# HUSQVARNA TECHNICAL BULLETIN HTB2603 – USA

## **\*RECALL - REMEDY NOTICE\***

### **E-THROTTLE ASSEMBLY REPLACEMENT**

#### **AFFECTED MODELS:**

Figure 1 – DMC label on e-throttle wiring

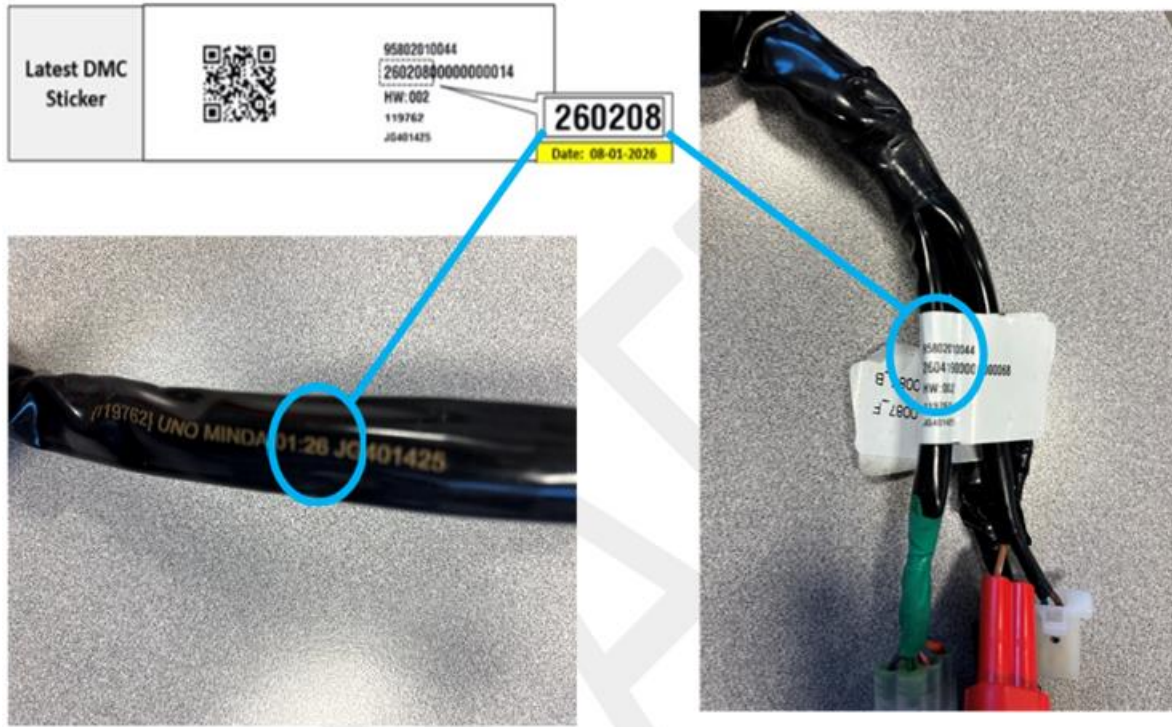
Destroy the old part by cutting off the connector, attach a photo of the destroyed part to the warranty claim. Improved parts can be recognized at the label attached or printed to the wiring of the part (see fig.1). Use only parts with production date starting with 26 (see example in fig.1).
